NOTICE OF ADDENDUM

ADDENDUM NO. 2

CITY OF MADISON
NAKOOSA TRAIL FLEET/FIRE/RADIO SHOP FACILITY

S-101E

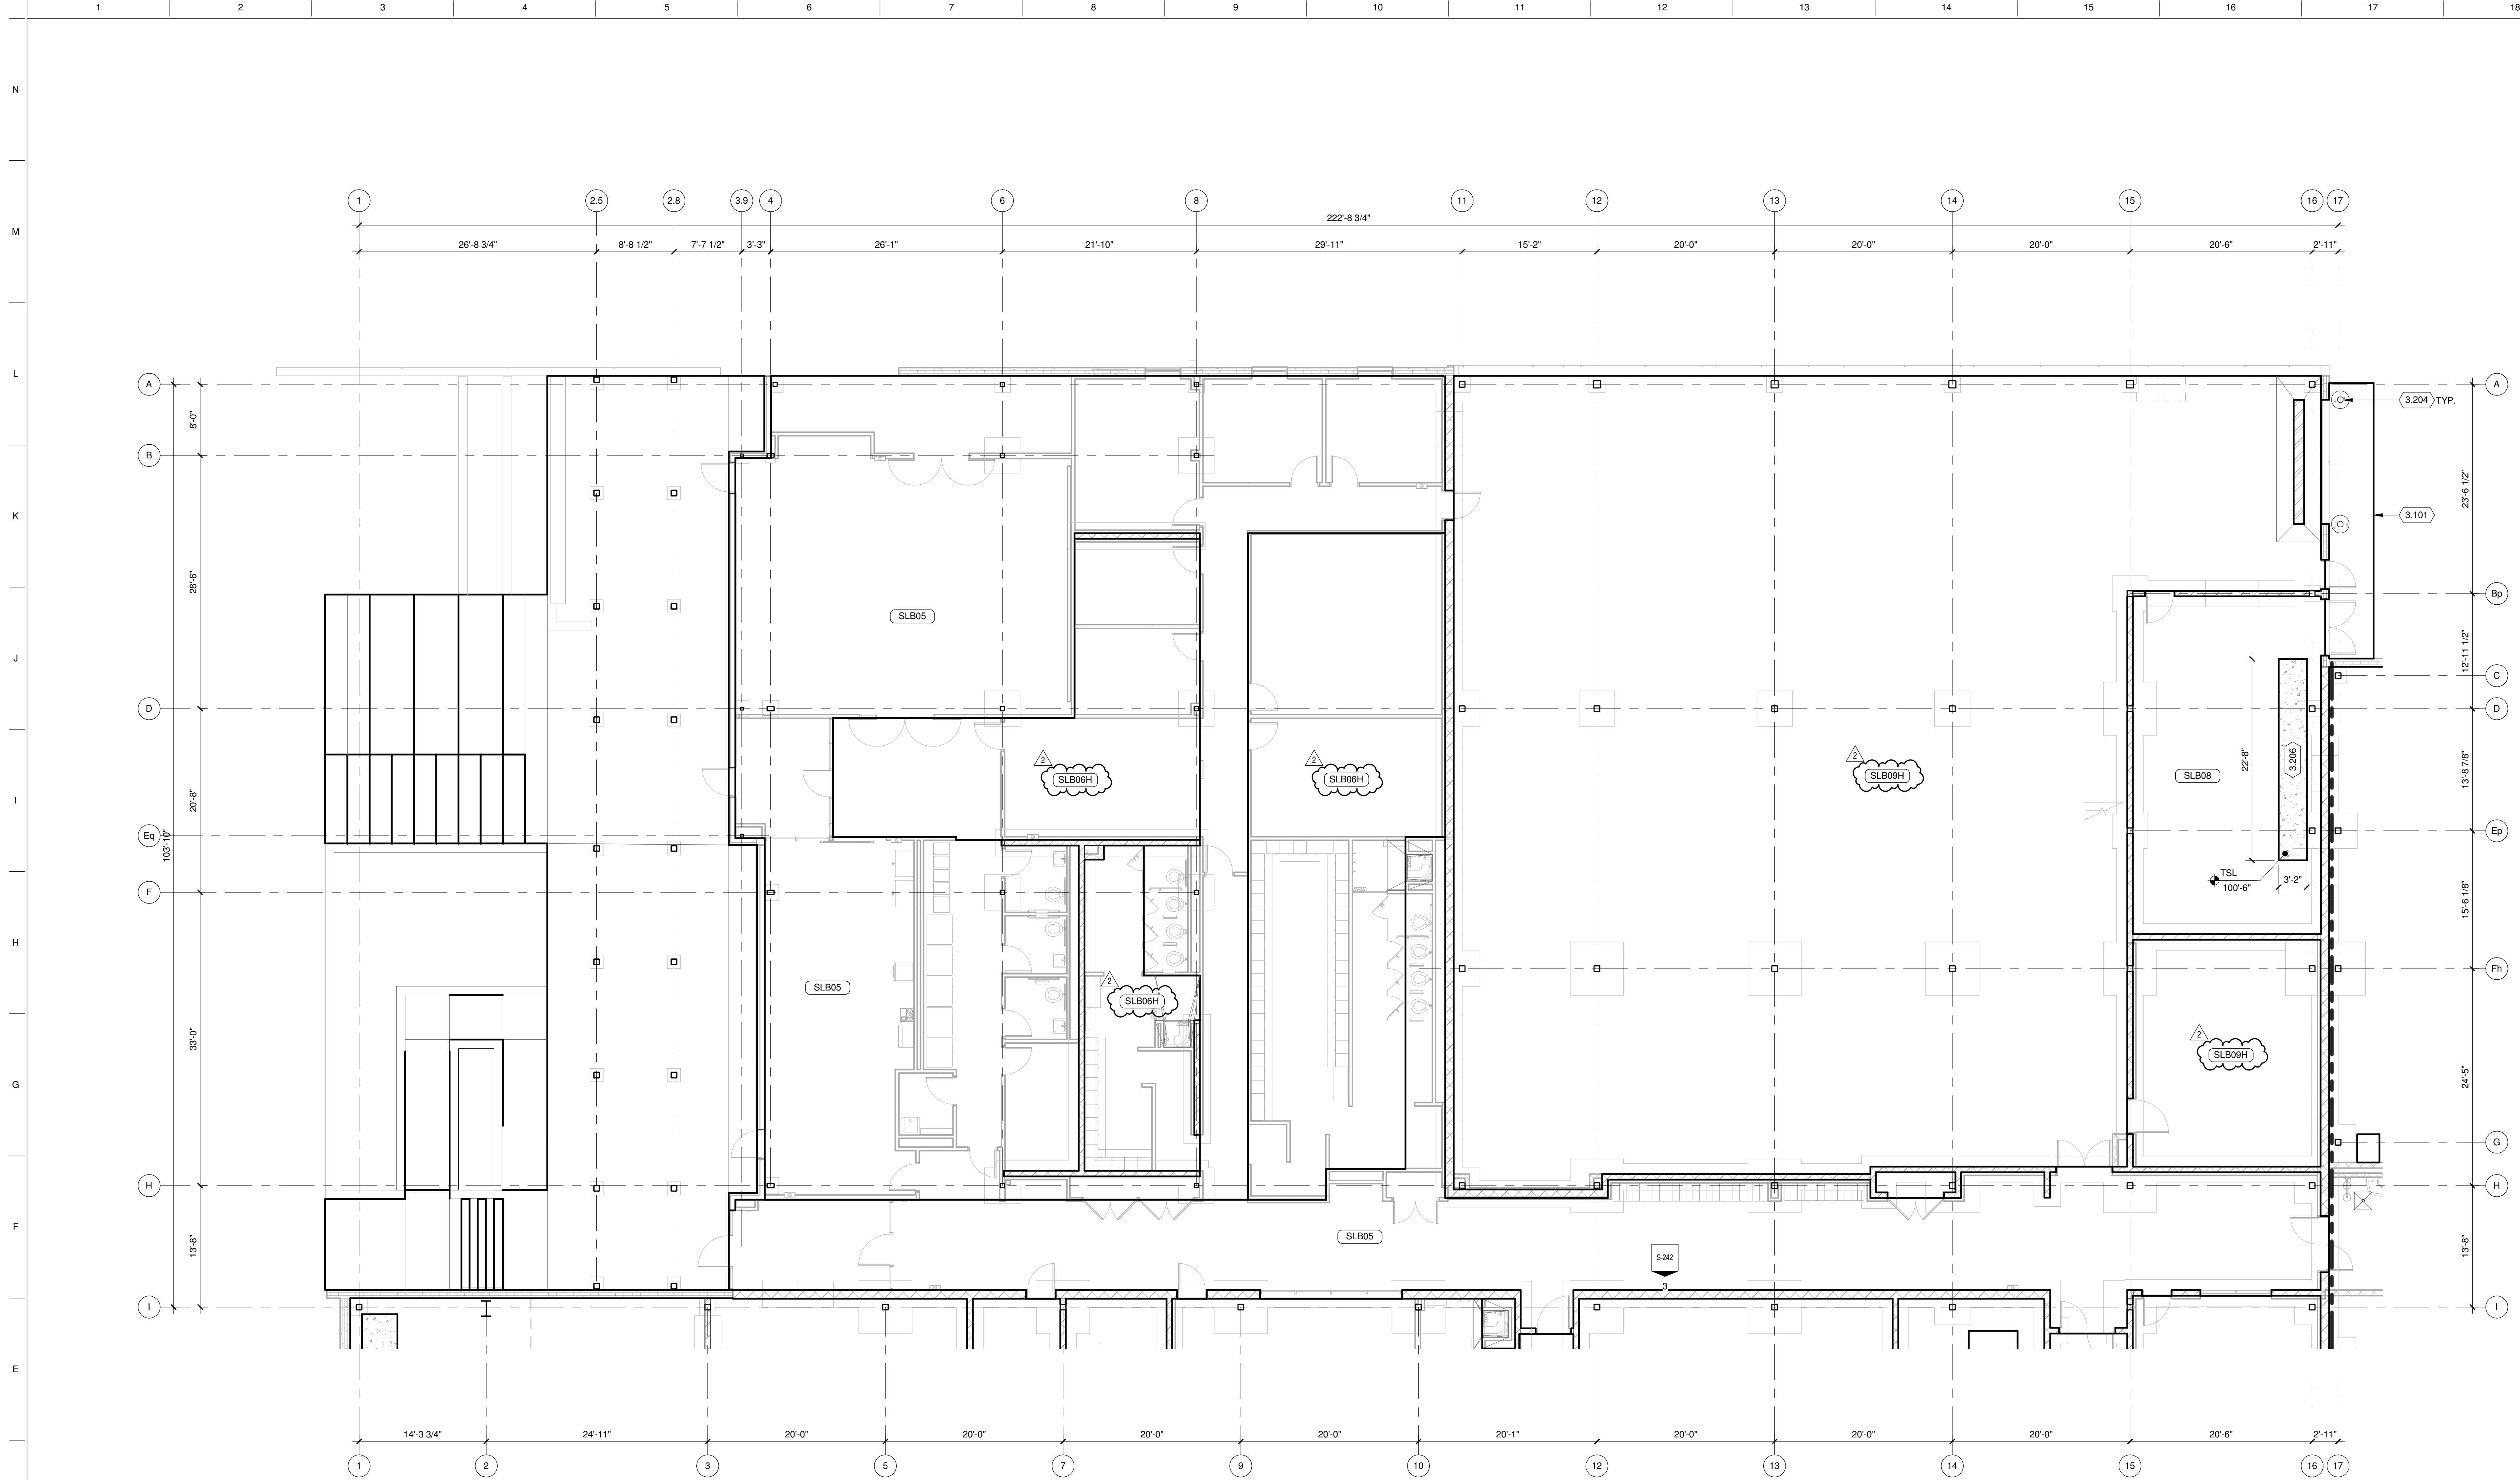
- VV. **MODIFIED** S-101E FOUNDATION PLAN AREA E to revise foundation as indicated.
- WW. **MODIFIED** S-111A FLATWORK PLAN AREA A to revise concrete slabs as indicated.

S-111D

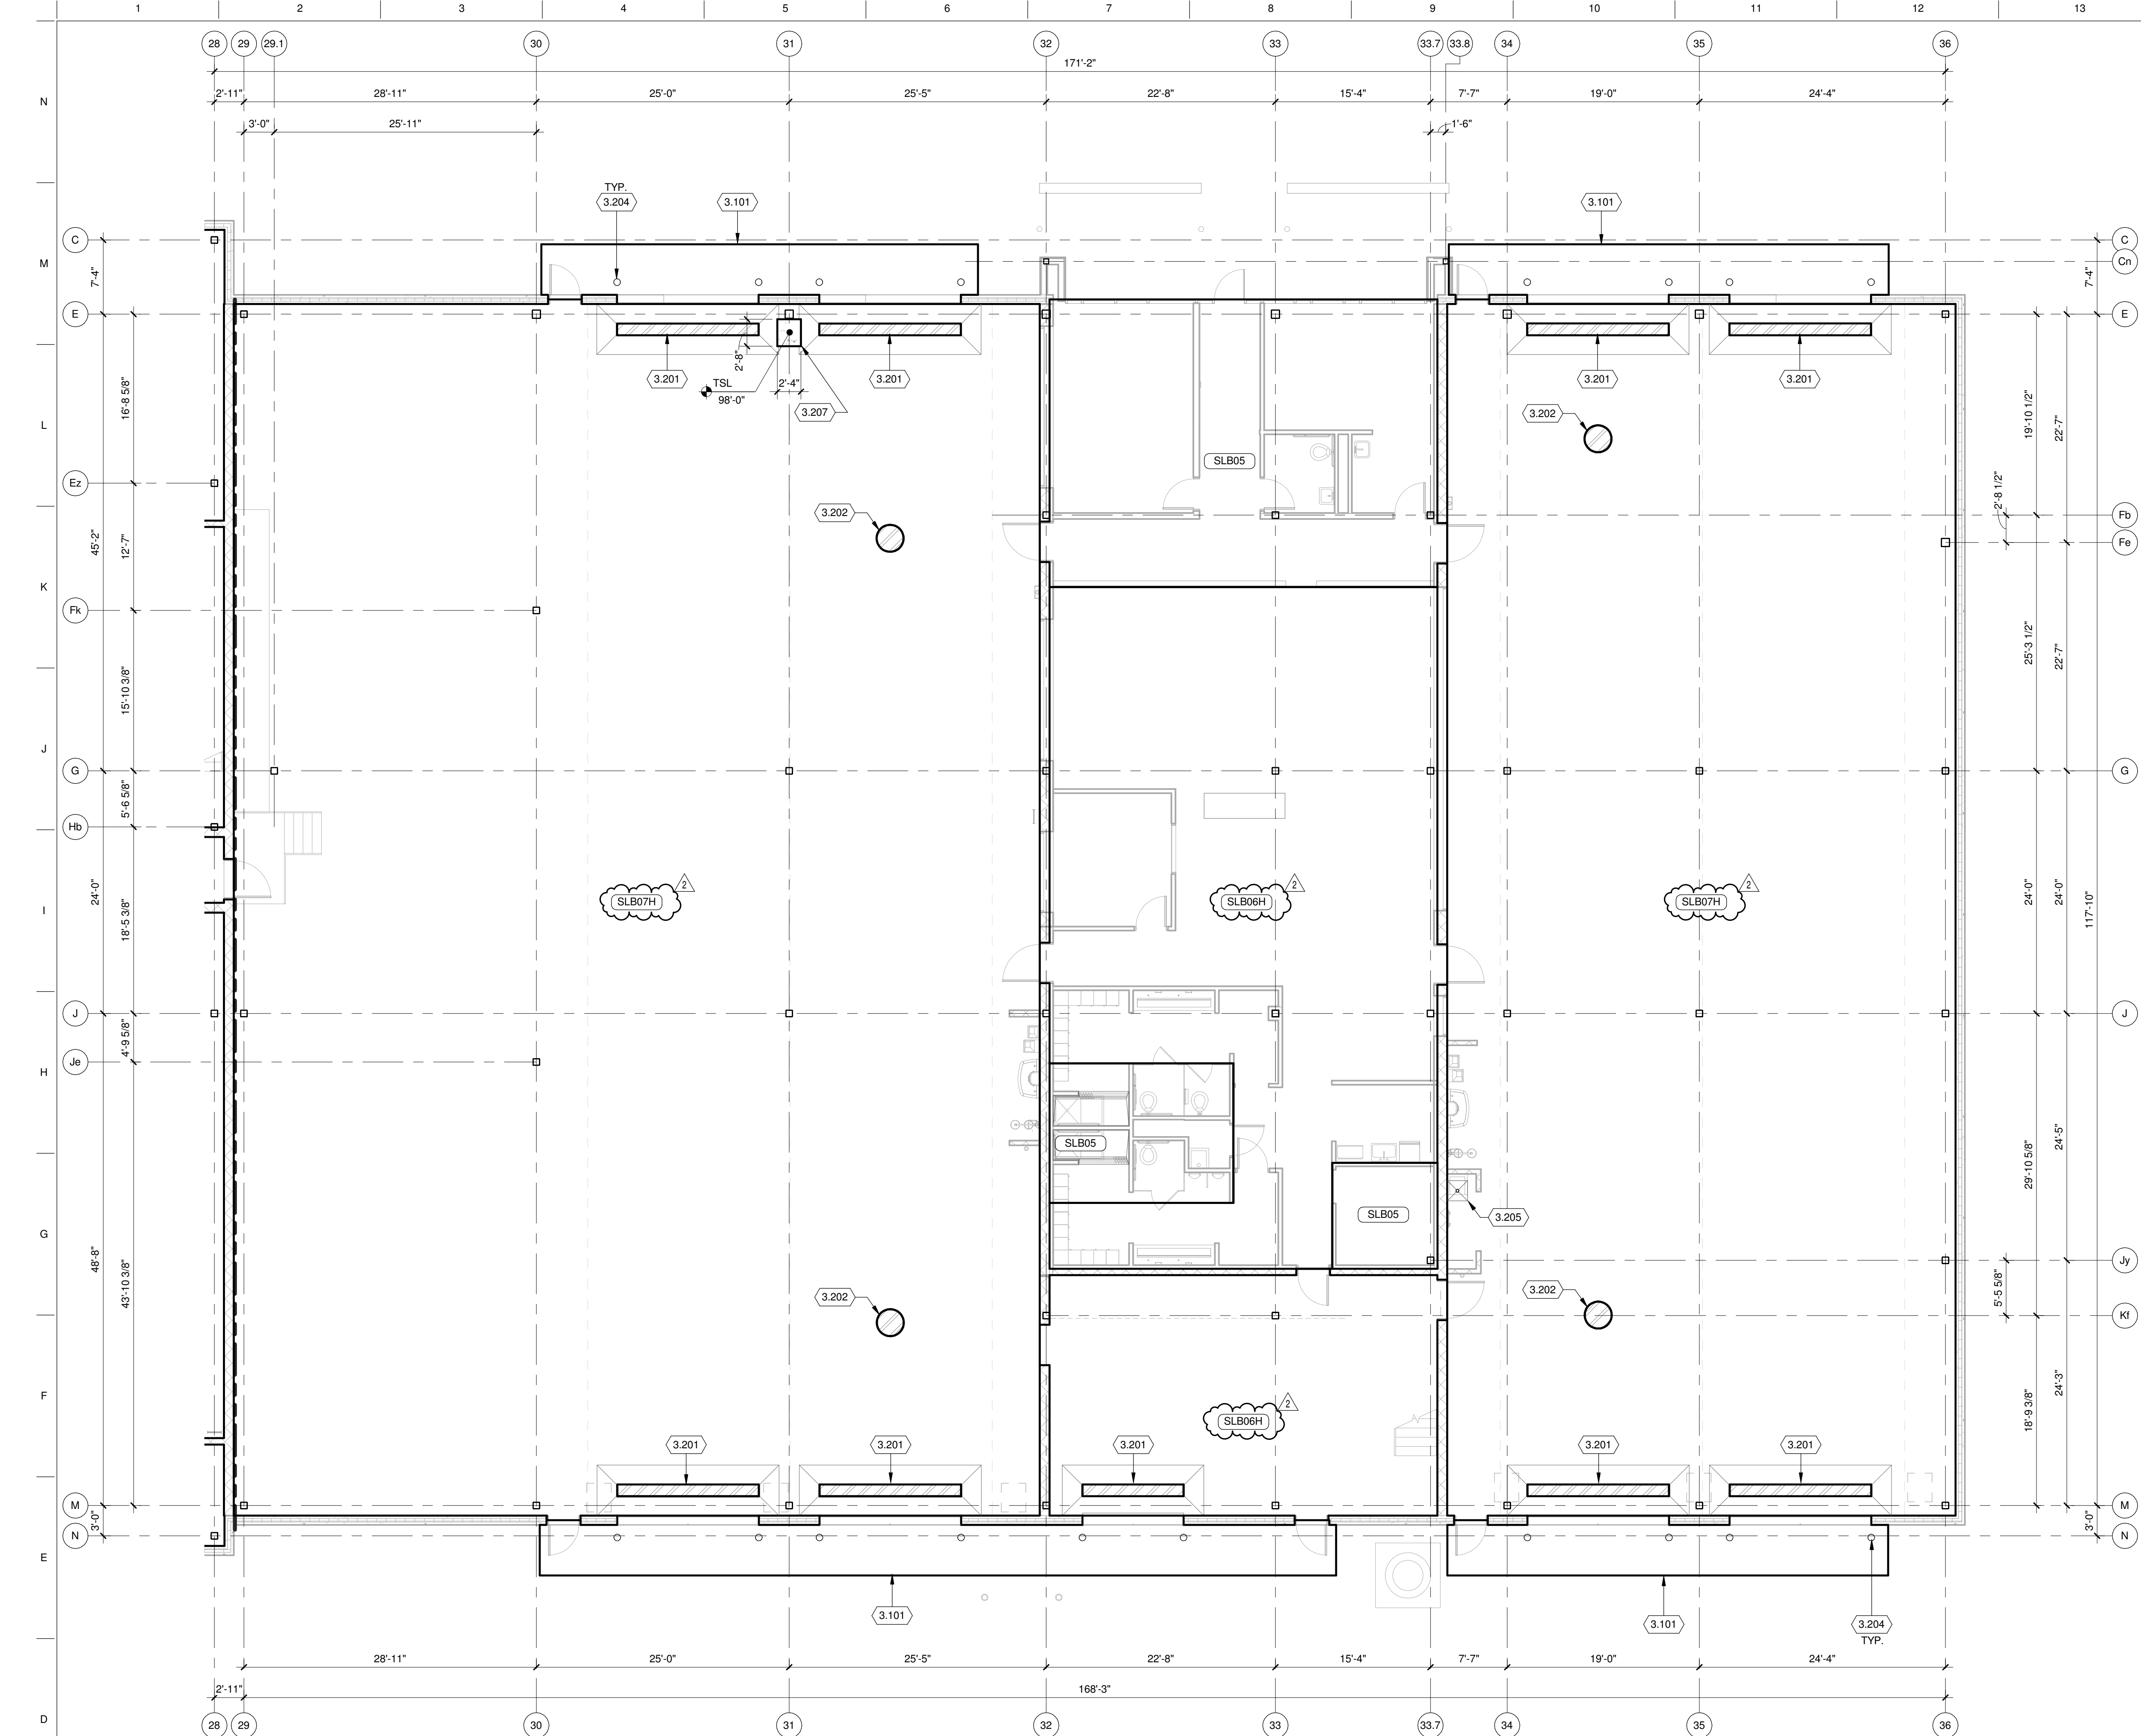
- ZZ. **MODIFIED** S-111D FLATWORK PLAN AREA D to revise concrete slabs as indicated and add equipment pads as indicated.
- AAA. **MODIFIED** S-111E FLATWORK PLAN AREA E to revise concrete slabs as indicated.

S-131A

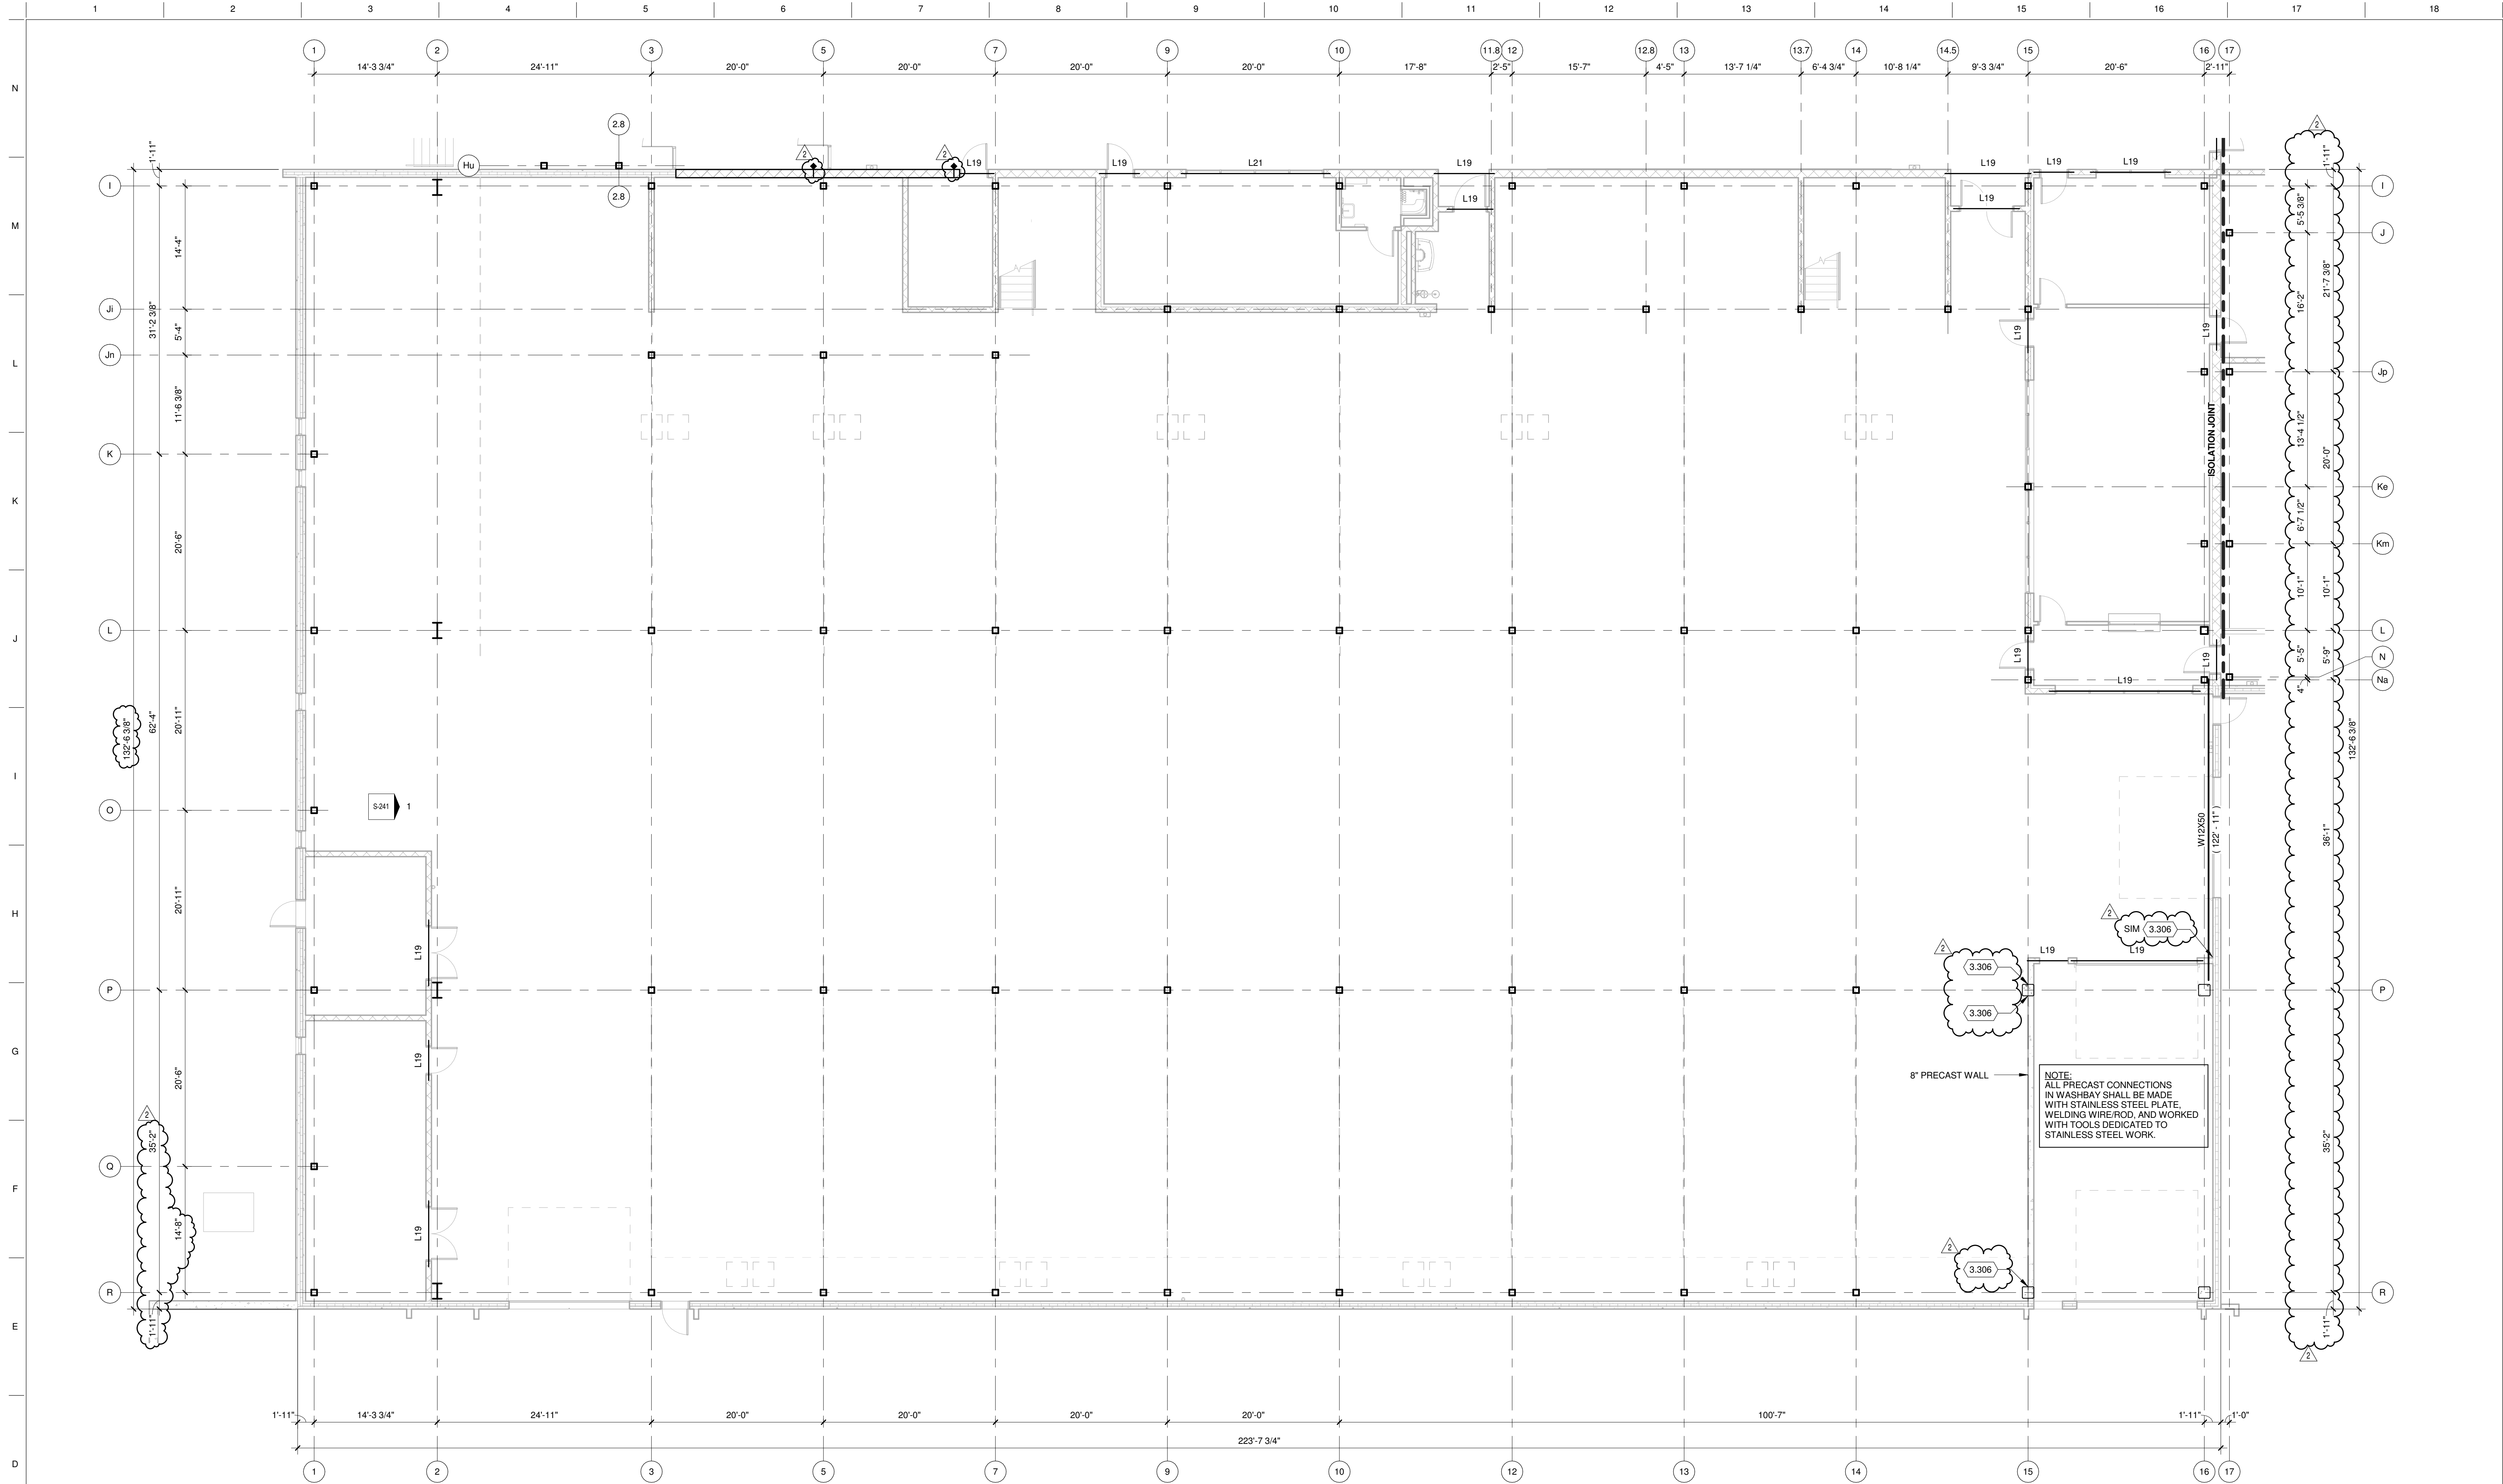
- BBB. **MODIFIED** S-131A LEVEL 1 STRUCTURAL FLOOR PLAN AREA A to add masonry control joints as indicated and revise Structural Floor Plan General Note 13 as indicated.
